Detailed response to Architectus' request for additional information (RFI 2 May 2021) DA/836/2020 Liverpool Civic Place

Proposed Mixed-Use Development Known as Liverpool Civic Place – 52 Scott Street, Liverpool

Liverpool Civic Place - DA RFI 2

3c Viewing Platform Vehicular Clearances

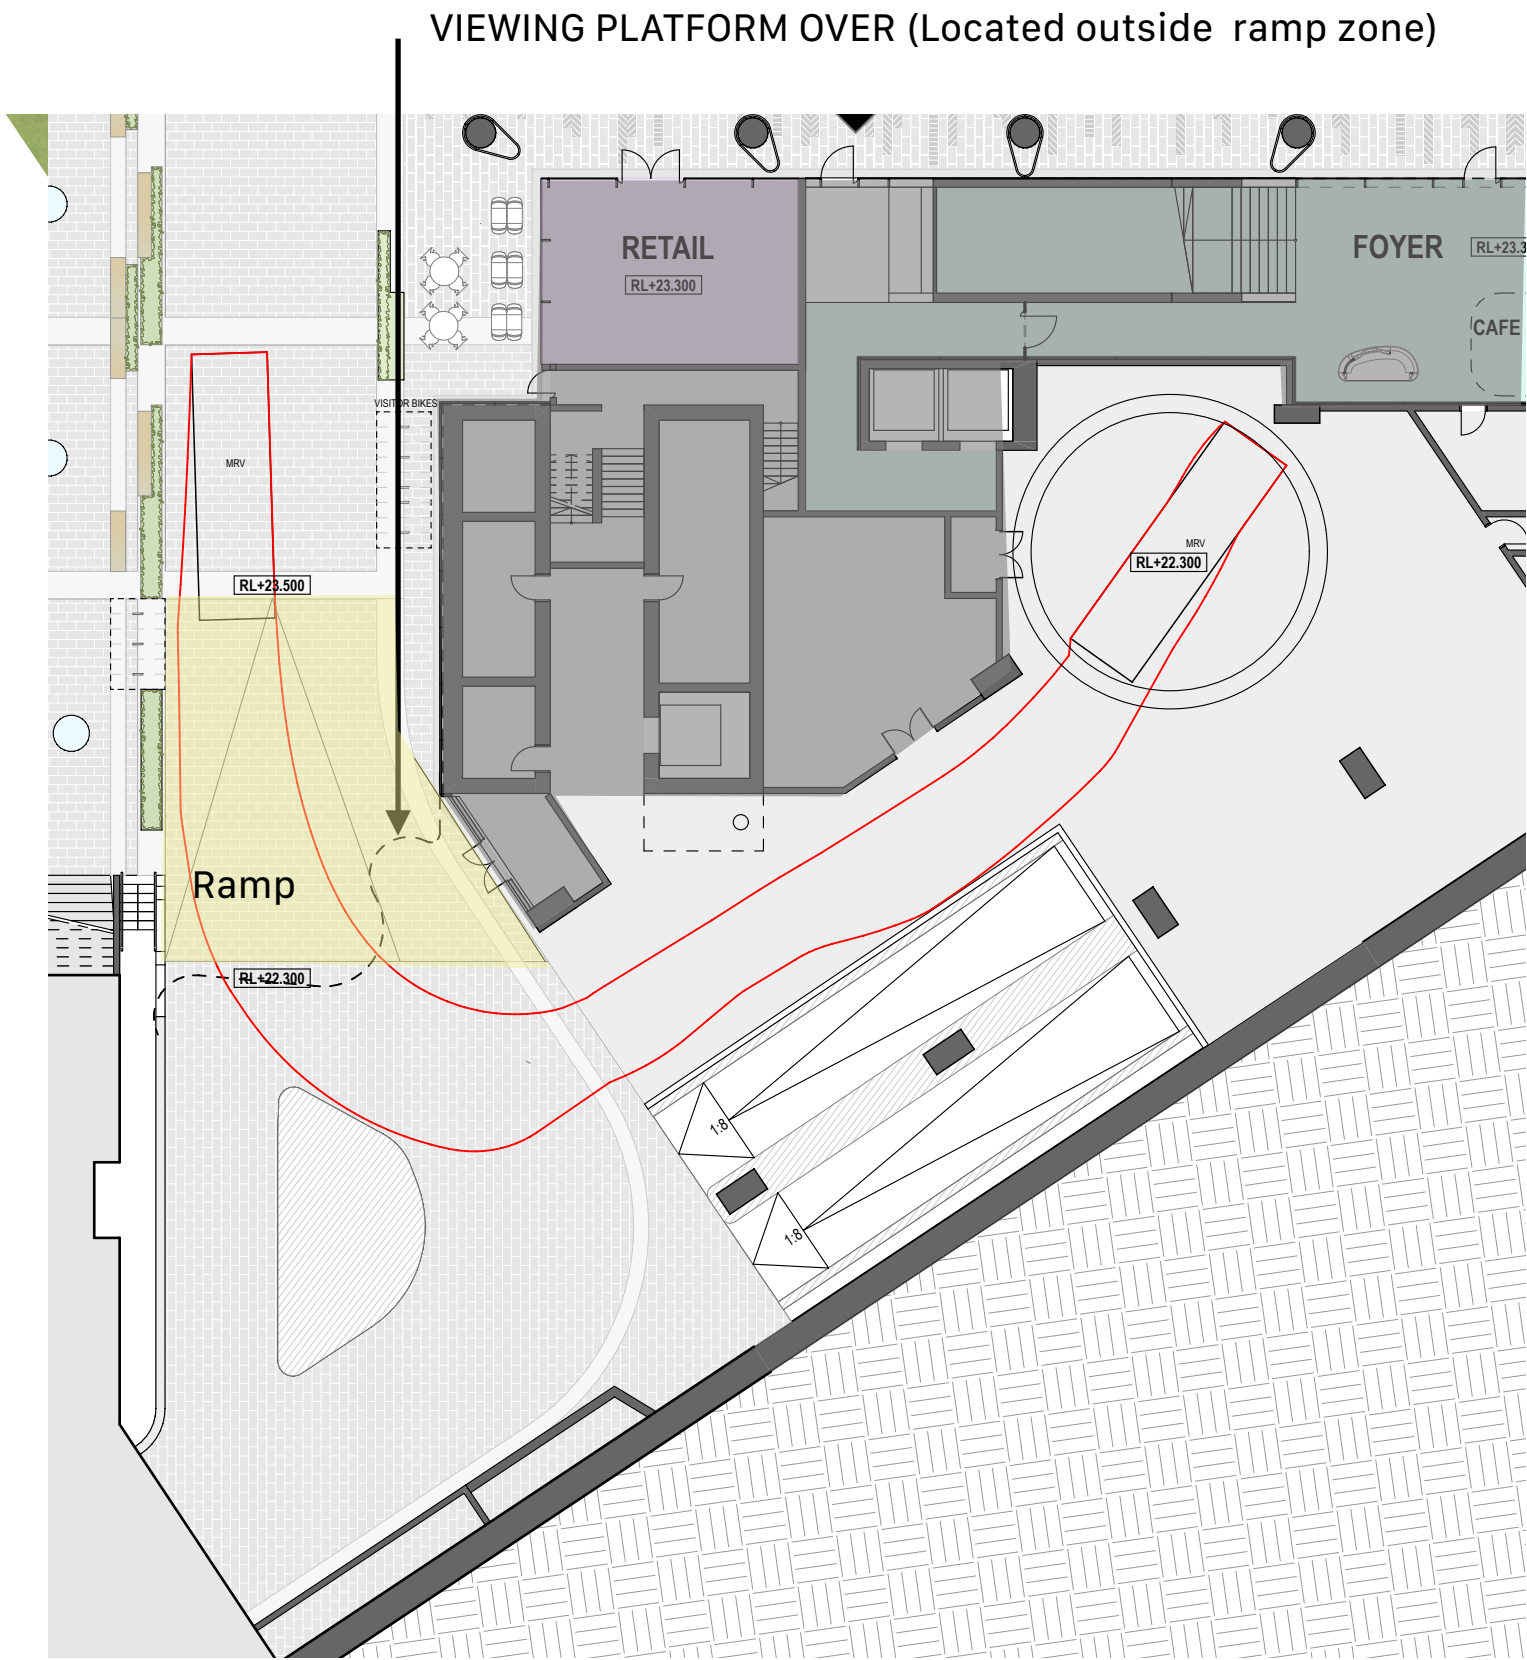
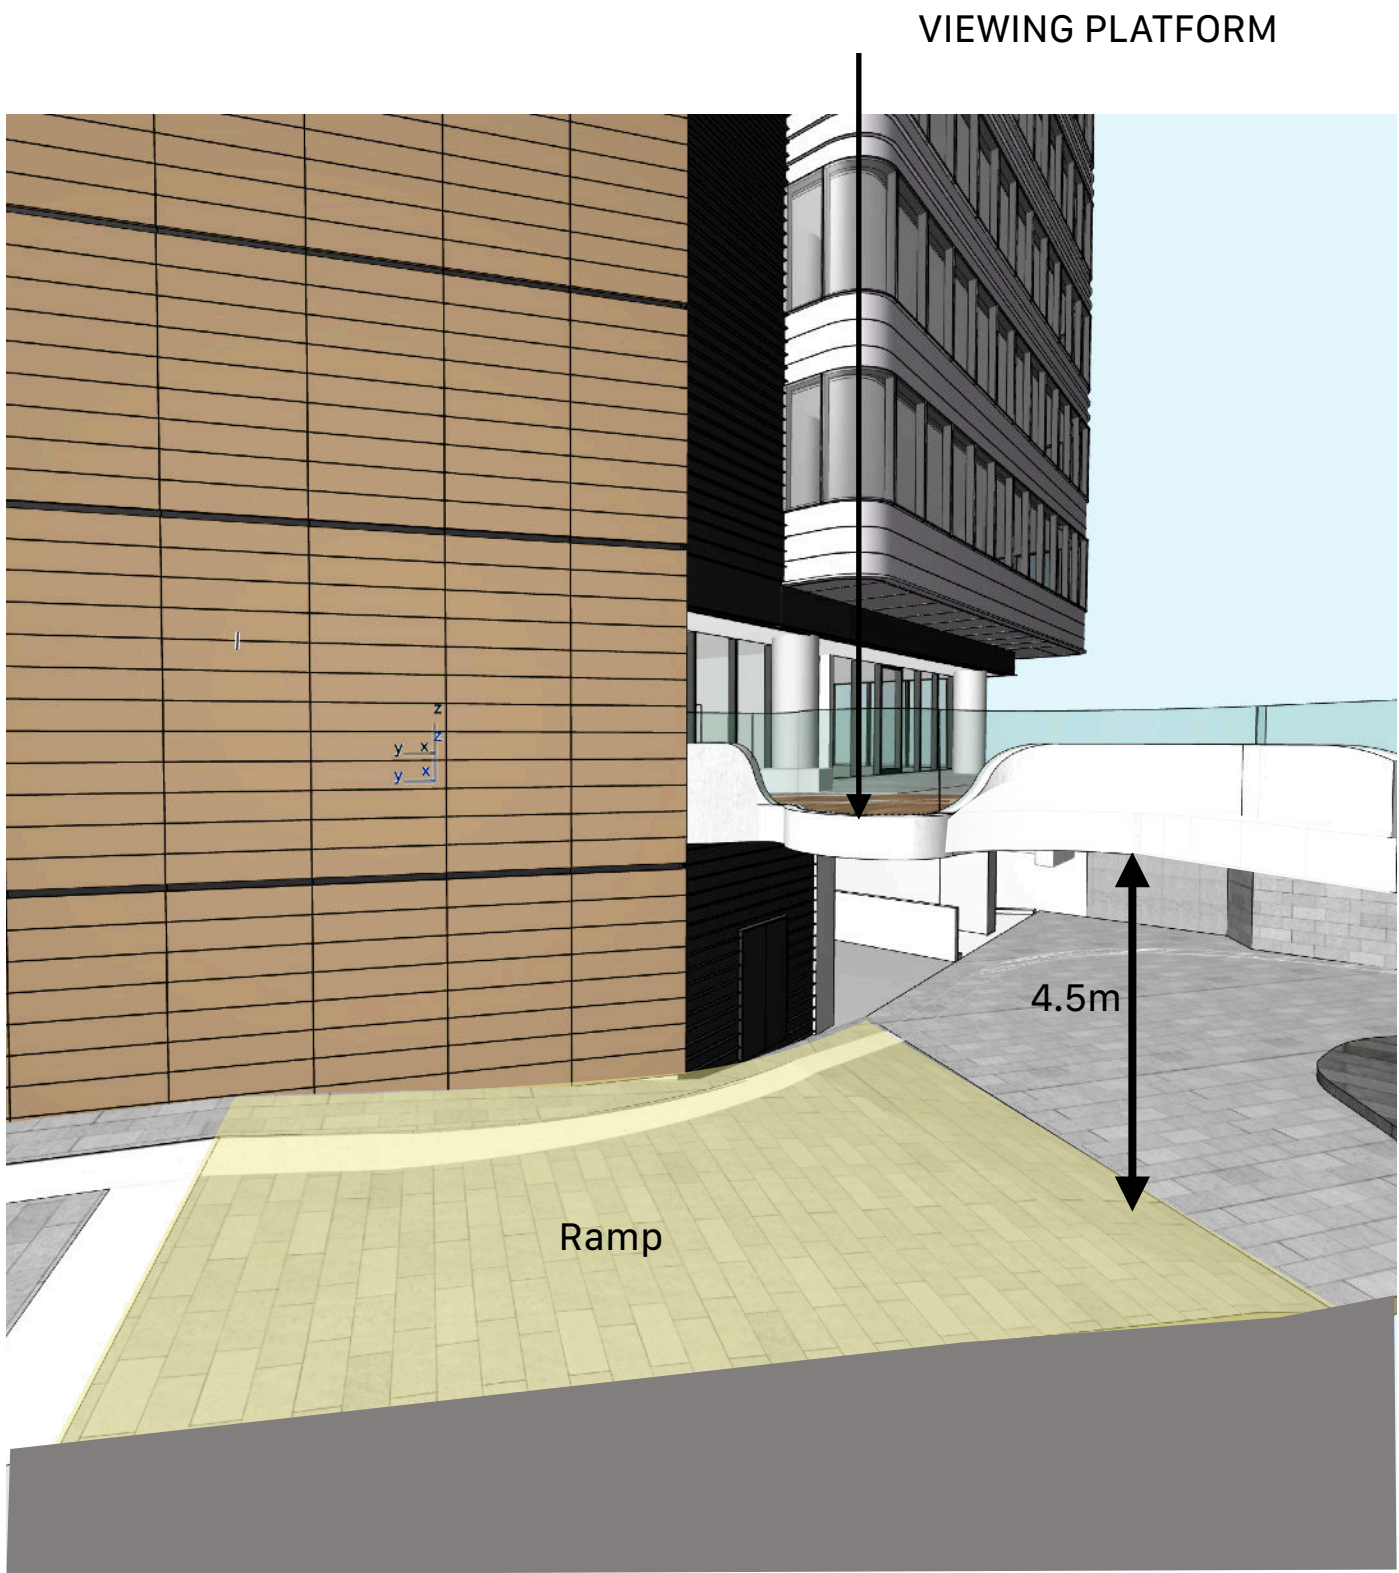
Is it noted that the revised public domain plan now includes a viewing terrace. This terrace extends further north as the sharezone ascends. In this regard, there is potential for this balcony to compromise the vertical clearance needed for servicing and delivery vehicles planned for DA-1080/2020. It is requested that the applicant confirm that the vertical clearance has not been compromised as a result of the terrace.

Confirming the viewing platform has been designed clear of the required service vehicle height clearances below. The viewing terrace is also shaped and positioned outside the MRV swept path zone. There is no vertical clearance compromise from accommodating the viewing platform. Further, the edge of the viewing platform will be profiled such that 4.5m clearance is achieved above the full width of the ramp (refer figure 4.)
